PROJECT: LSTK JOB FOR ISBL WORK OF 220kV GRID POWER IMPORT AT PANIPAT REFINERY
LOA NO. RPRC182491/26286965 DTD.24.01.2020

TITLE 220/33KV SWITCHYARD-SINGLE LINE DIAGRAM

DRAWING/ DOCUMENT NO. TB-411-510-001

Comments Resolution Sheet for

GROUND FLOOR

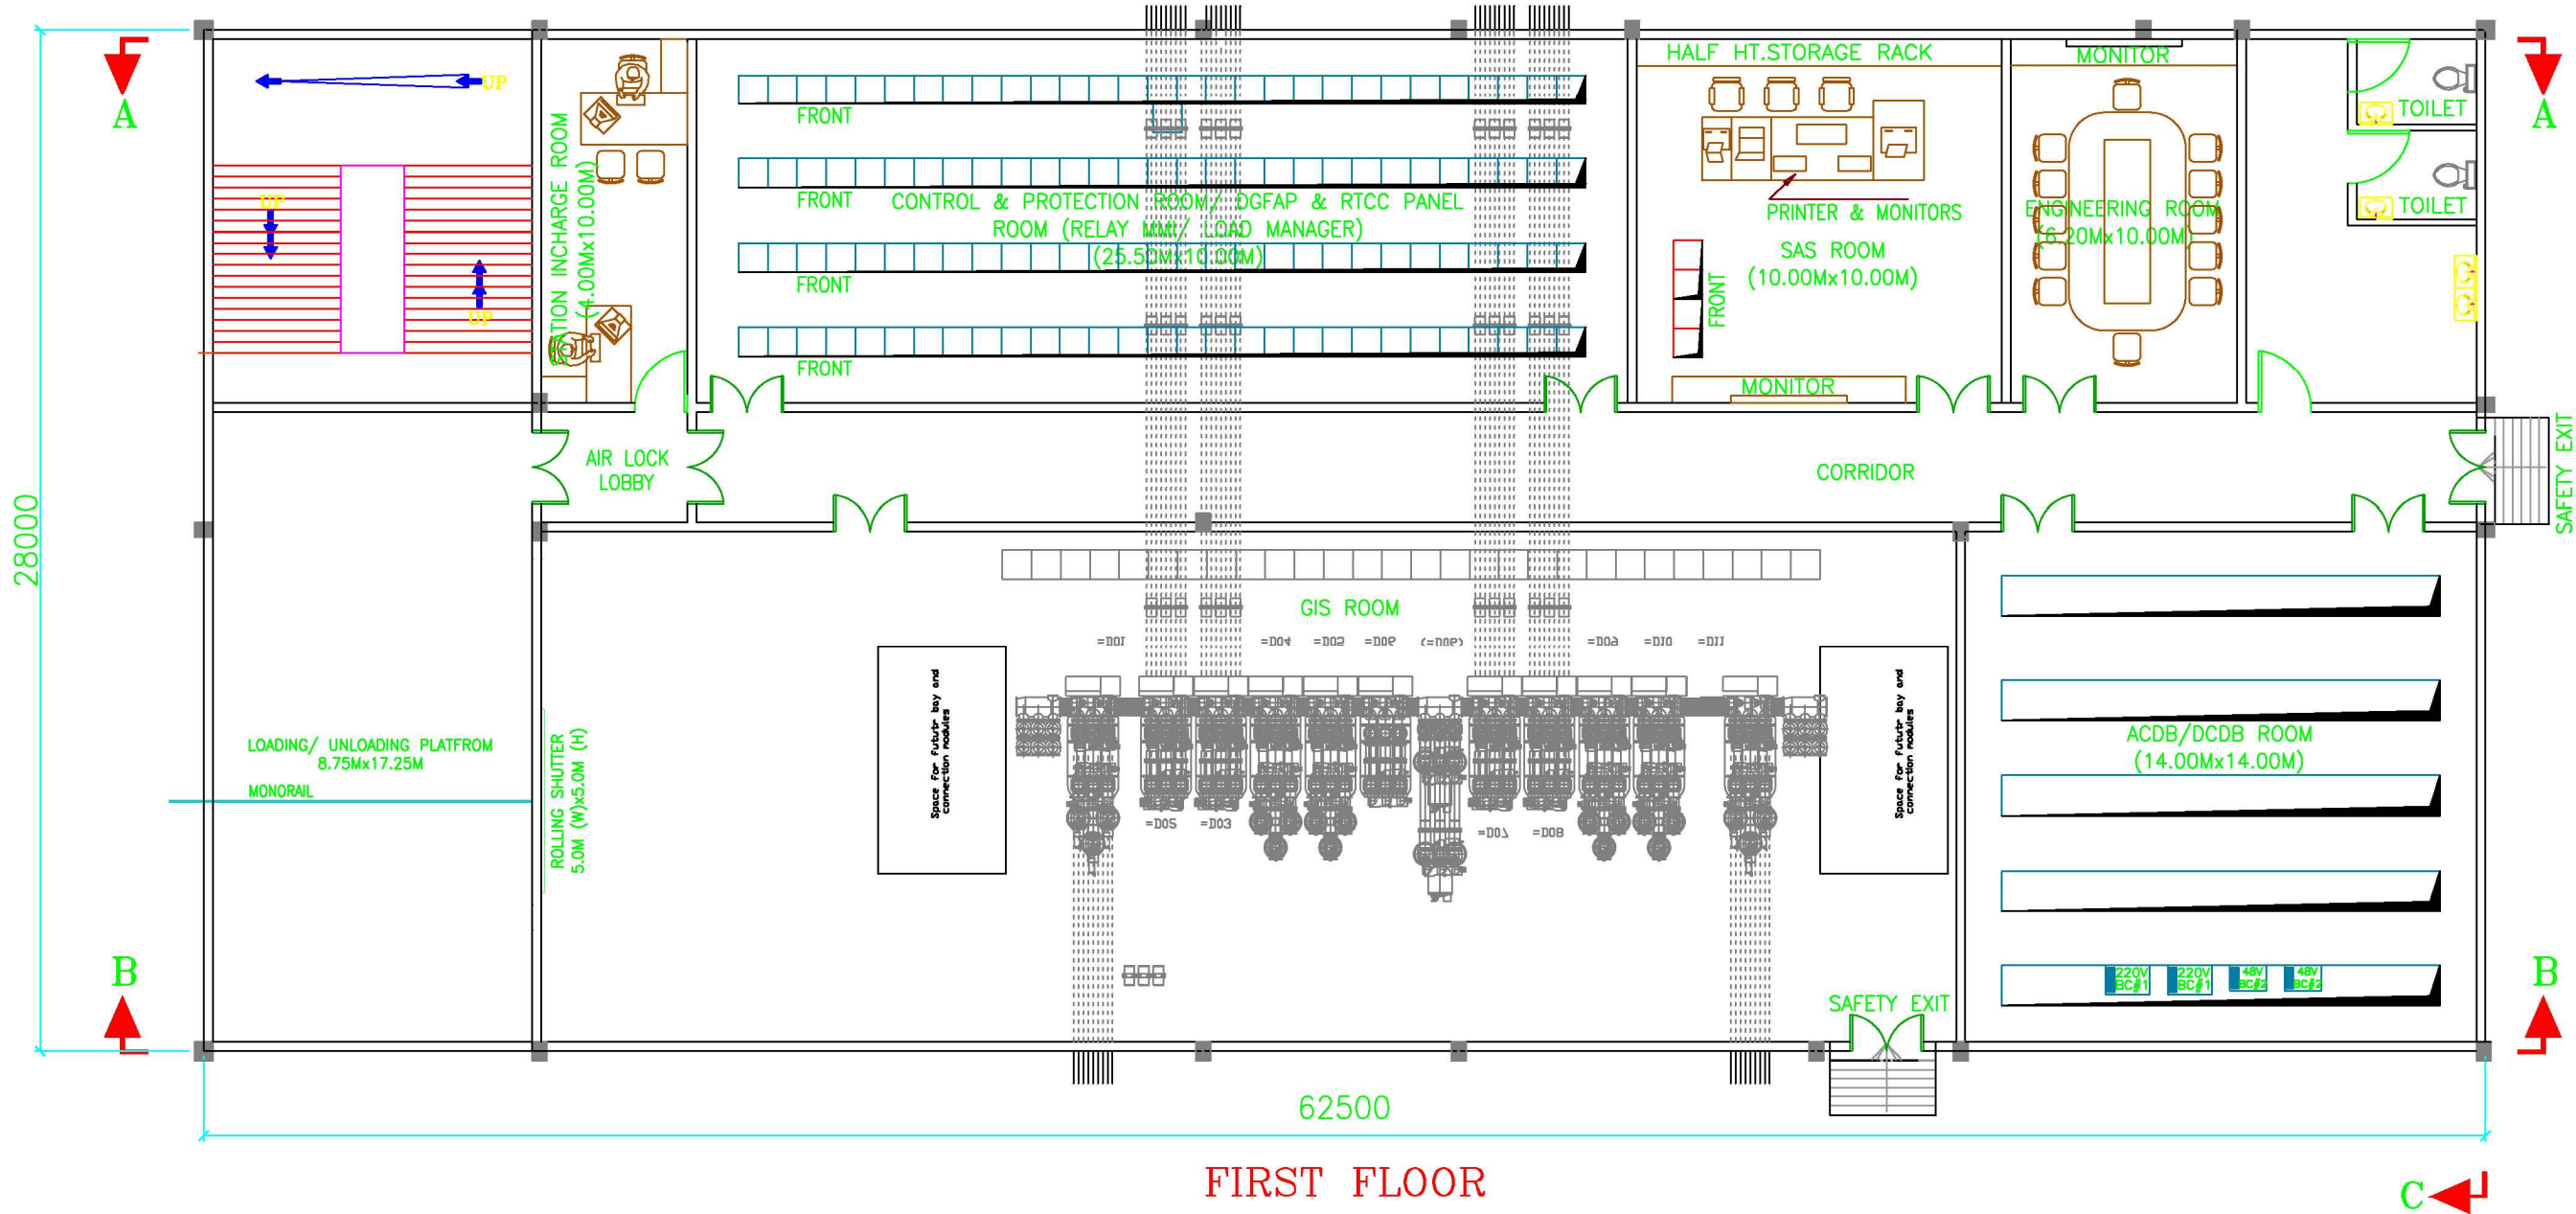
Sl. No.	Drawing Reference Details	Comment (s)/ Observation(s)	Resolution(s)
A.	CONSULTANT (dtd. 16.03.2020)		
	Electrical		
1	Plan	GIS LCC panel shall be shown as one per bay with dimension of 1000-1200mm as per vendor input.	Noted. Please note that such details are tentative and shall be revised, if required in line with OEM drawings/ design documents.
2	Plan	Wherever column comes SF6 Duct or Cable Opening shall be rearranged to avoid fouling.	Noted. Please note that such details are tentative. Civil and structure design documents shall be submitted subsequently after approval of this drawing/ document.
3	Plan	GIS bays shall be placed in between beams and not on beams.	Noted. Please note that such details are tentative. Civil and structure design documents shall be submitted subsequently after approval of this drawing/ document.
4	Plan	ACDB & DCDB shall be aligned as per as per cable trench route proposed	Noted. Please note that such details are tentative and shall be revised, if required in line with OEM drawings/ design documents.

5	Plan	No of staircase to be check considering building size as per relevant building standards.	Noted. Please note that such details are tentative. Civil and structure design documents shall be submitted subsequently after approval of this drawing/ document.
6	Plan	More sections to be provided showing GIS room with EOT crane arrangement, loading platform etc.	Noted. Please note that such details are tentative. Civil and structure design documents shall be submitted subsequently after approval of this drawing/ document.
7	Plan	No of exit to be check considering building size as per relevant building standards.	Noted and complied.
8	Plan	All inner dimension of rooms shall be provided. All dimension between panel to panel, panel to wall etc to be shown.	Noted. Please note that such details are tentative. Civil and structure design documents shall be submitted subsequently after approval of this drawing/ document.

Sl. No.	Drawing Reference Details	Comment (s)/ Observation(s)	Resolution(s)
9	Plan	NIFPS panel shall be shown	Noted. Please note that such details are tentative and shall be revised, if required in line with OEM drawings/ design documents.
10	Plan	TR-3 (trench type) name mentioned in 1st floor GIS room to be removed	Noted and revised.
11	Plan	Exhaust fan arrangement for Toilet & Pantry to be shown	Noted. Please note that such details are tentative and shall be revised, if required in line with OEM drawings/ design documents.
12	Section A-A	Cable termination arrangement in SAS/ Control room to be shown. Whether False floor to be provided or else cable entry for panel will be from top.	Noted. Please note that such details are tentative and shall be revised, if required in line with OEM drawings/ design documents.
13	Plan	In ground floor GIS & LCC panel can be shown dotted as it is placed on 1st floor. Bus duct to be shown in ground floor	Noted. Please note that such details are tentative and shall be revised, if required in line with OEM drawings/ design documents.

14	Plan	Bay name shall be mention for each GIS module	Noted. Please note that such details are tentative and shall be revised, if required in line with OEM drawings/ design documents.
15	Plan	No. of CRP panels shown is more compared with 220kV feeders. Panel identification shall be done. CRP panel alignment to be checked.	Noted. Please note that such details are tentative and shall be revised, if required in line with OEM drawings/ design documents.
16	Plan	Eye wash to be provided in battery room	Noted. Please note that such details are tentative. Civil and structure design documents shall be submitted subsequently after approval of this drawing/ document.

Sl. No.	Drawing Reference Details	Comment (s)/ Observation(s)	Resolution(s)
17	Plan	UPS not shown in drawing	Noted. Please note that such details are tentative and shall be revised, if required in line with OEM drawings/ design documents.
18	Plan	TR-2 cable trench (3Mtr wide) shown for battery room cables is too large for cables coming from battery room to DC system.	Noted and Revised.
19	Plan	Door to be provided in 1st floor staircase for entering into loading/unloading platform	In first floor, staircase shall not be covered and it shall be open. Civil and structure design documents shall be submitted subsequently after approval of this drawing/ document.
20	General	Room with false ceiling & false floor shall be shown in section drawing	Noted. Please note that such details are tentative. Civil and structure design documents shall be submitted subsequently after approval of this drawing/ document.

21	Plan	Steps & door shall be shown at ground floor stair case entry point	In ground floor, staircase shall not be covered and it shall be open. Civil and structure design documents shall be submitted subsequently after approval of this drawing/ document.
22	GIS room	GIS room height shown as 11mtrs in 220/33kV layout Plan & Section. Kindly confirm	Noted and revised.
23	Plan	Bus duct for transformer bay can be optimise by routing it from cable cellar. ACDB & DCDB room can be optimised in size to avoid fouling with bus duct.	This is finalized and frozen in line with Customer requirement and consent.
24	Plan	Additional door (near SAS room) to be shown for entry in GIS room	Noted and revised.

Sl. No.	Drawing Reference Details	Comment (s)/ Observation(s)	Resolution(s)
25	Plan	Roof layout indicating busduct shall be provided	Please note that these details are tentative and indicated and shall be revised based on OEM drawings, which shall be submitted separately and such requirements shall be taken care during that.
26	Section A-A	Raised floor / power cable entry, HVAC cable entry to be shown.	Please note that these details are tentative and indicated and shall be revised based on OEM drawings, which shall be submitted separately and such requirements shall be taken care during that.
27		EHV cable trench is passing below the HVAC room. Kindly reroute the EHV cable to avoid fouling.	In ground floor, staircase shall not be covered and it shall be open. Civil/ Mechanical drawing shall be submitted subsequently after approval of this drawing/ document.
28		Service shaft / fire hose shall be shown in drawing	In ground floor, staircase shall not be covered and it shall be open. Civil/ Mechanical drawing shall be submitted subsequently after approval of this drawing/ document.

Sl. No.	Drawing Reference Details	Comment (s)/ Observation(s)	Resolution(s)
33		Store Room of GIS building to have access from outside with ramp & rolling shutter	Revised details are provided.
34		Kindly review reroute busduct from cable cellar to GIS room to avoid cutout in ground floor slab. Also please review route of GIB to transformer if it can be optimised.	Please note that these details are tentative and indicated and shall be revised based on OEM drawings, which shall be submitted separately and such requirements shall be taken care during that.
35		Periphery road size to be increase for transportation of GIS & other equipment. 4mtr road will not be sufficient.	This is finalized and frozen in line with Customer requirement and consent.
36	Section A-A	Parapet wall to be shown on roof of building	In ground floor, staircase shall not be covered and it shall be open. Civil/ Mechanical drawing shall be submitted subsequently after approval of this drawing/ document.

Sl. No.	Drawing Reference Details	Comment (s)/ Observation(s)	Resolution(s)
39	Plan	Wall not to be shown in 1st floor (West side) for loading/unloading platform	In ground floor, staircase shall not be covered and it shall be open. Civil/ Mechanical drawing shall be submitted subsequently after approval of this drawing/ document.
40		All door opening shall be outside the room	In ground floor, staircase shall not be covered and it shall be open. Civil/ Mechanical drawing shall be submitted subsequently after approval of this drawing/ document.
41	Section A-A	Beam to be shown in all rooms to verify the height of room for erection of panel & false ceiling etc.	In ground floor, staircase shall not be covered and it shall be open. Civil/ Mechanical drawing shall be submitted subsequently after approval of this drawing/ document.
42	Plan	Dimensions of building to be shown Centre to centre. Inner room dimension to be provided in civil drawing	Please note that the dimesnion shown are clear electrical dimensions, which shall be taken care in civil drawings, which shall be submitted separately.

SECTION A-A

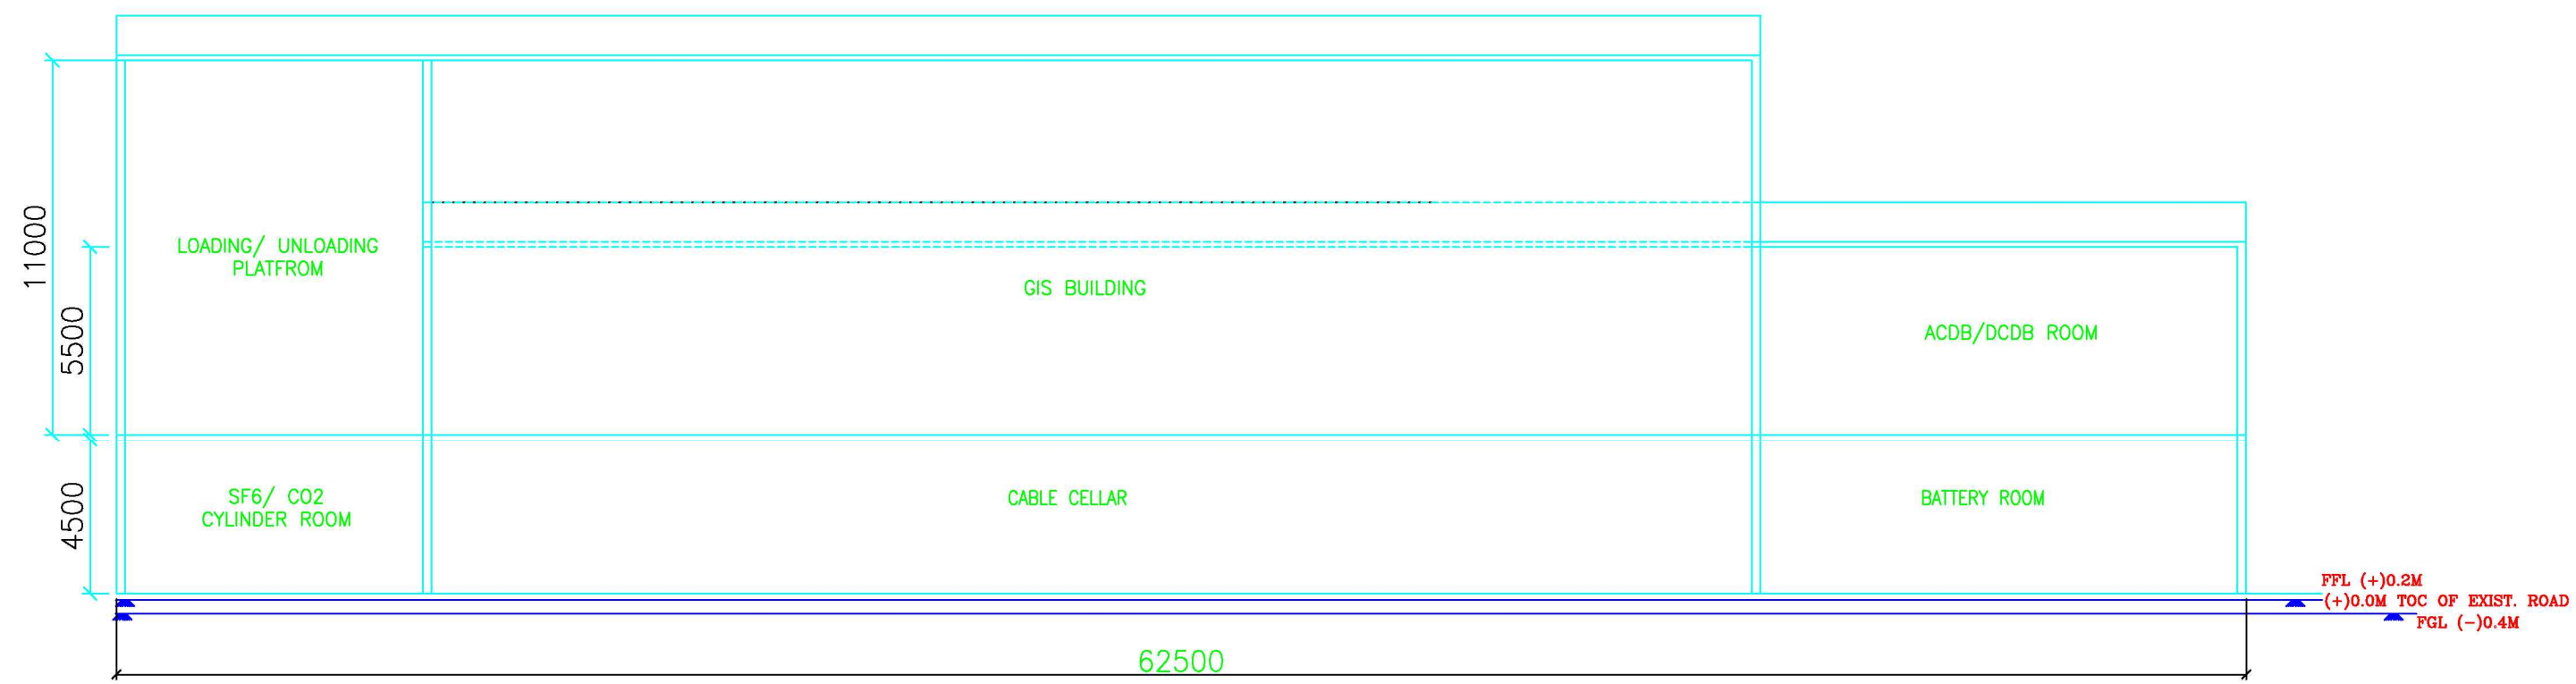
Civil & General		
29	General	Layout can be optimised	Noted.
30	Section A-A	Floor level to be shown	Noted and revised.
31	Plan	Columns shall be placed at equidistant. Kindly check no. of column shown in drawings.	In ground floor, staircase shall not be covered and it shall be open. Civil/ Mechanical drawing shall be submitted subsequently after approval of this drawing/ document.
32		GIS room clear span is 14.0 m, which may be critical during design / execution.	In ground floor, staircase shall not be covered and it shall be open. Civil/ Mechanical drawing shall be submitted subsequently after approval of this drawing/ document.

37	Section A-A	Staircase to be shown till the top of GIS building	In ground floor, staircase shall not be covered and it shall be open. Civil/ Mechanical drawing shall be submitted subsequently after approval of this drawing/ document.
38		Door for 220kV GIS room shall be shifted towards west side to avoid fouling with future bays LCC panels	In ground floor, staircase shall not be covered and it shall be open. Civil/ Mechanical drawing shall be submitted subsequently after approval of this drawing/ document.
